ADDENDUM NO. 2

MAKUU OFFSITE WATER SYSTEM PHASE 2 PRODUCTION WELL, RESERVOIR AND SUPPORTING FACILITIES

HALONA, PUNA, ISLAND OF HAWAII, HAWAII

IFB NO.: IFB-13-HHL-002

AT HALONA, PUNA, ISLAND OF HAWAII, HAWAII

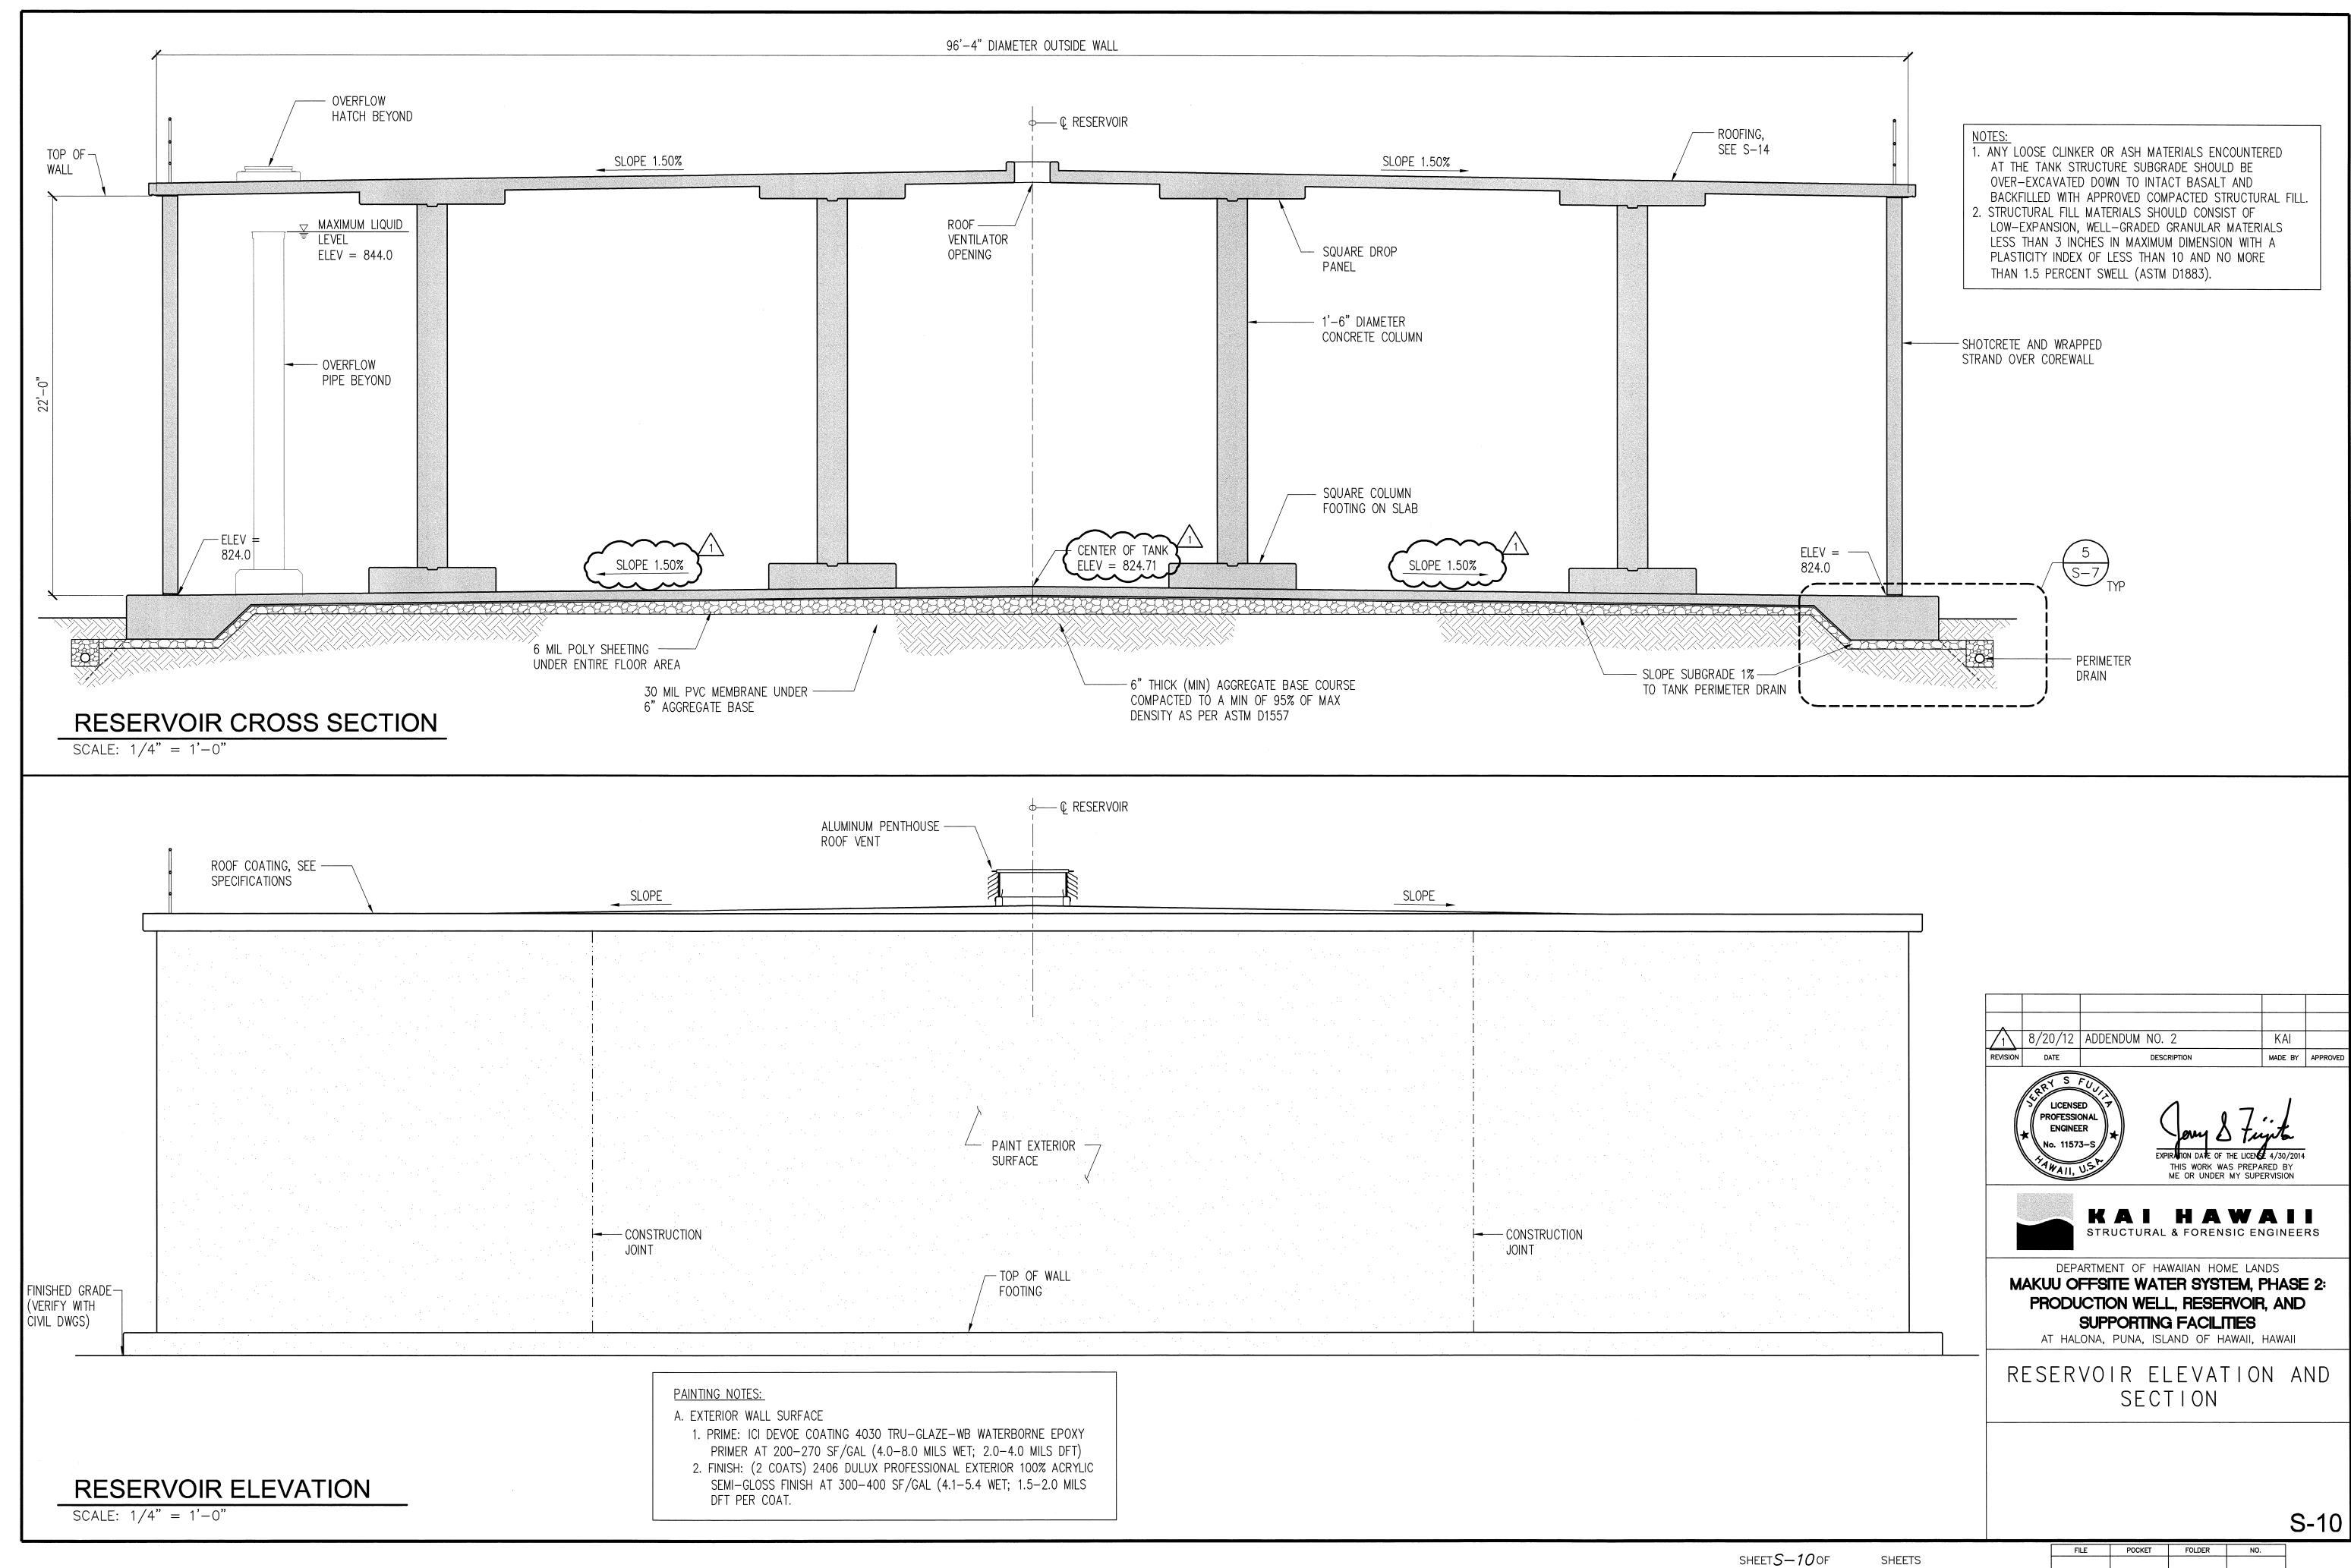
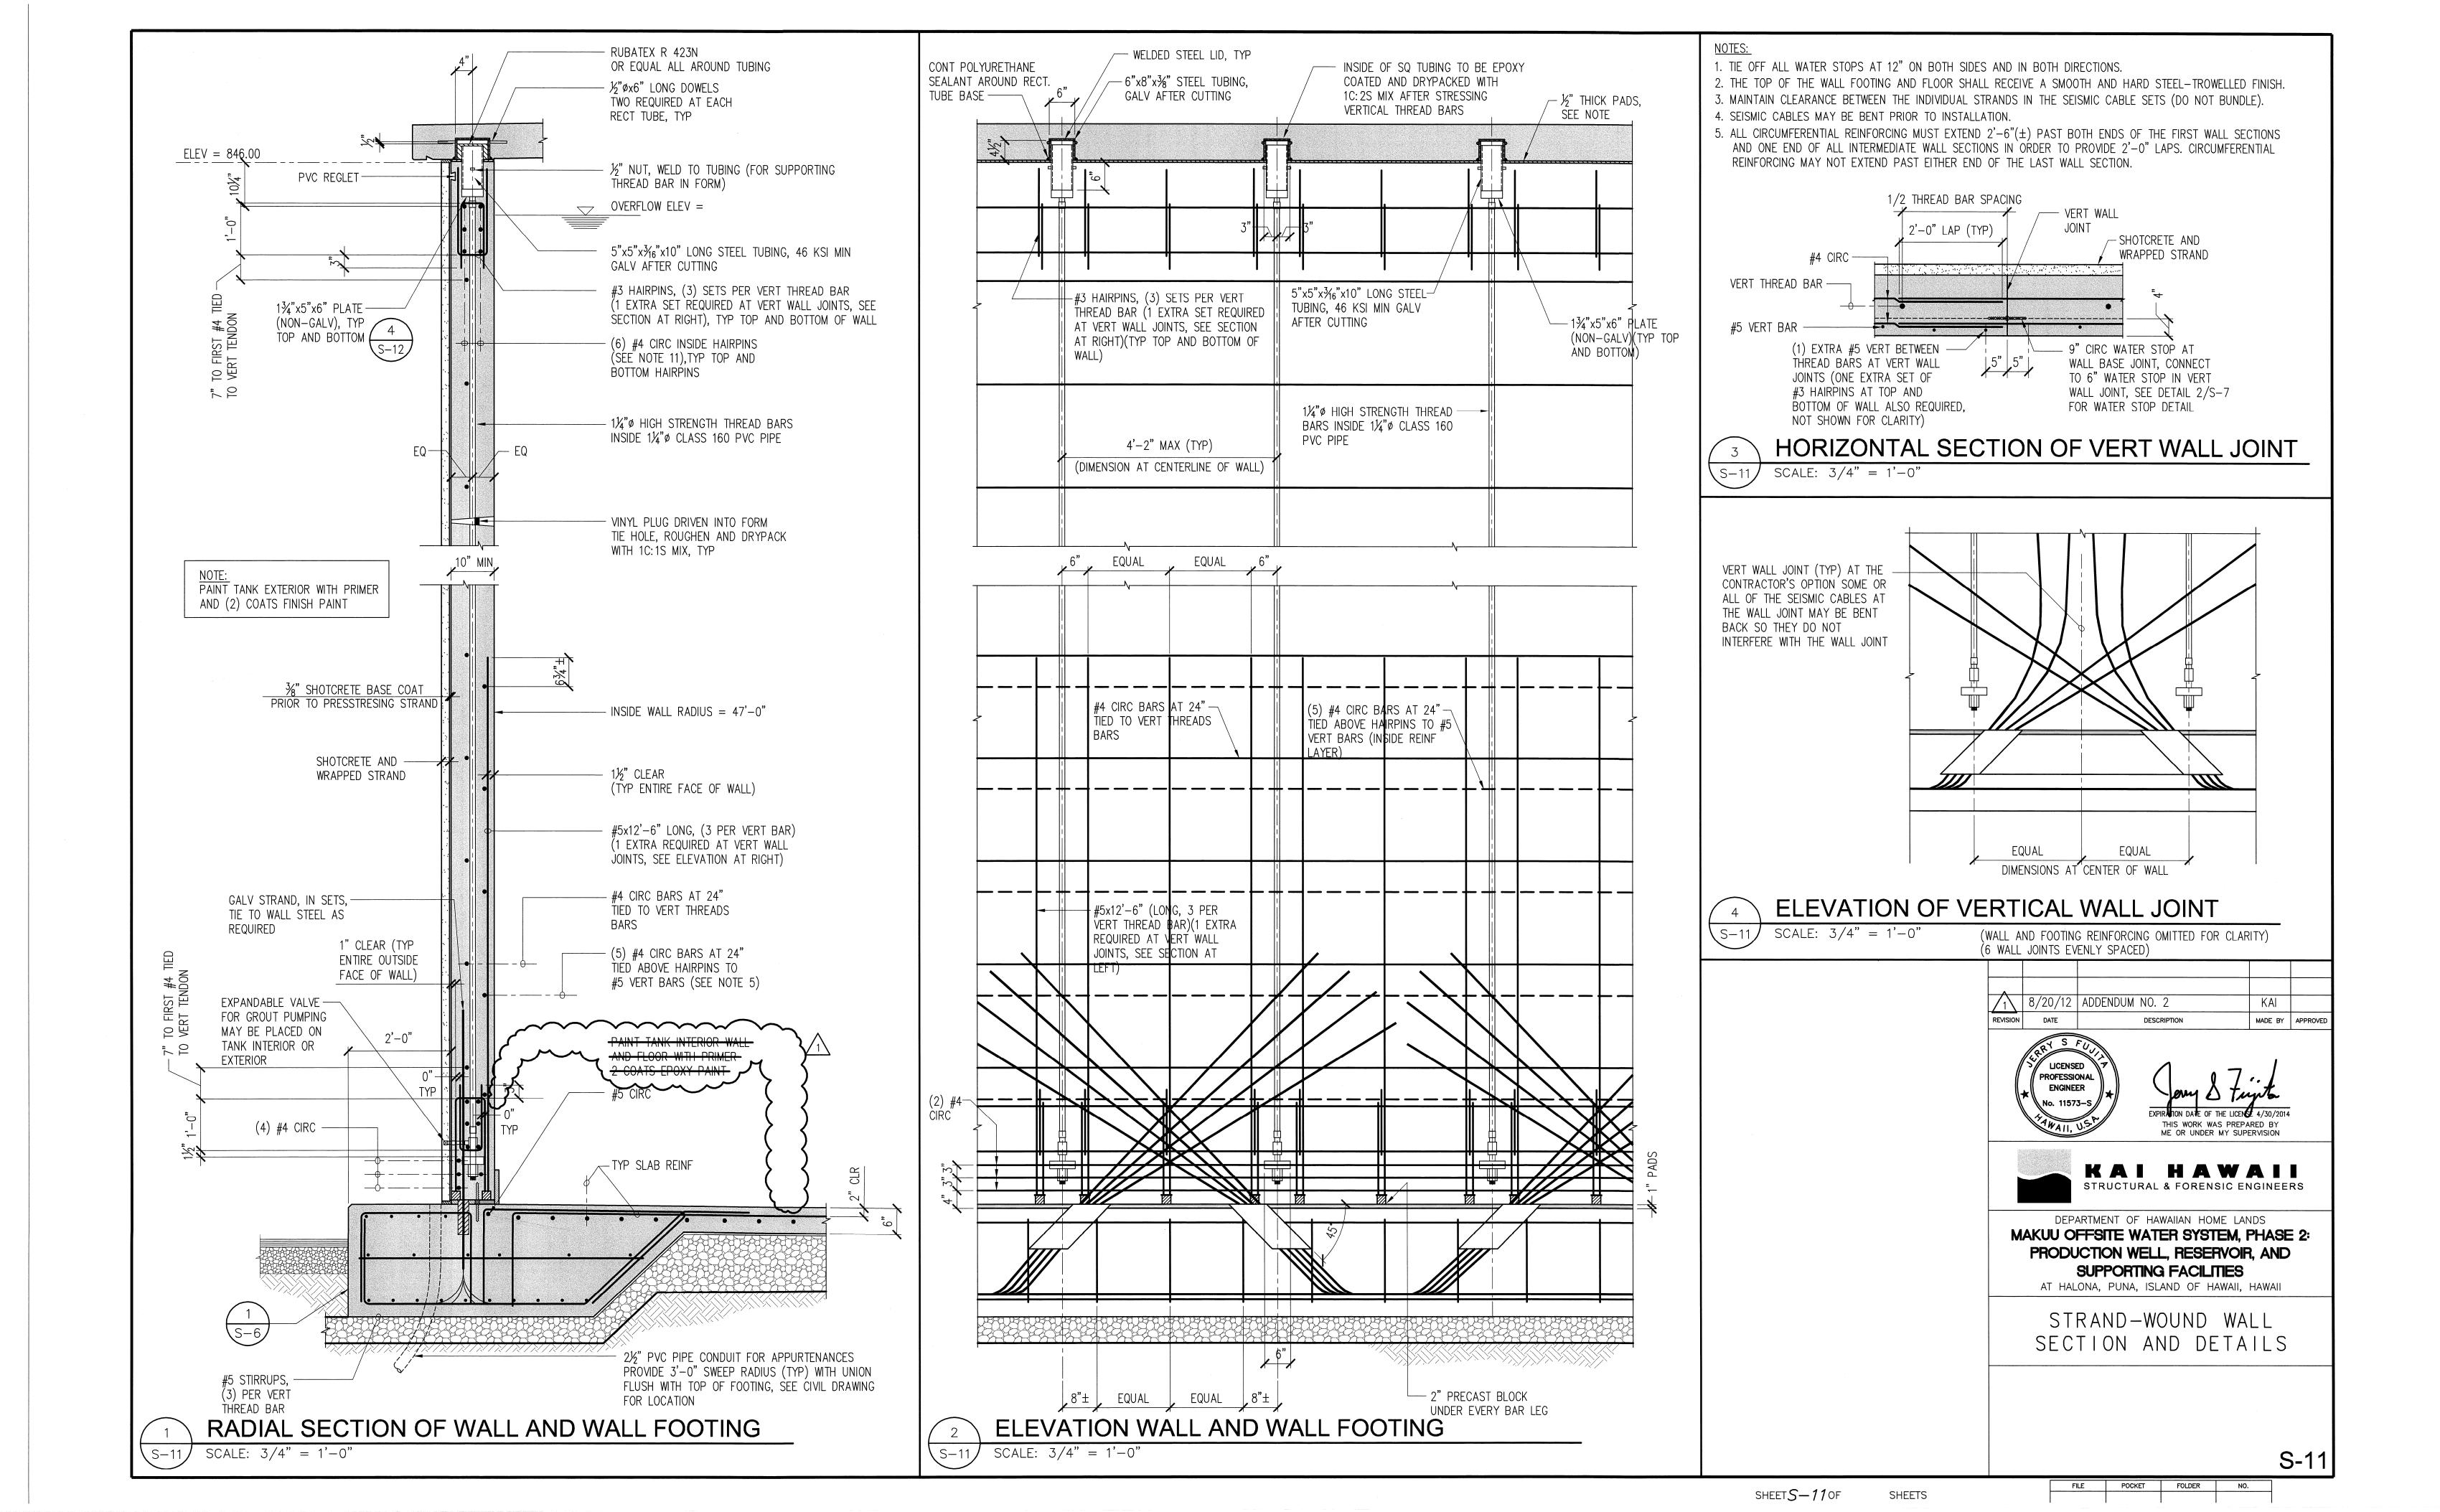
Section 303.07.F.2.n states the Importance Factor shall be 1.5 while Sheet S-4 of the drawings states the Importance Factor is 1.25. ACI 350 and AWWA D110 use 1.25 for essential facilities while IBC 2006 uses 1.5 for essential facilities. It is our understanding that Hawaii has recently adopted IBC 2006. Please have the Engineer review and determine if the project should also include IBC 2006 as part of Section 303.07.F.1 and the General Notes on Sheet S-4 of the plans and if the Importance Factor for the project should include both 1.25 and 1.5.
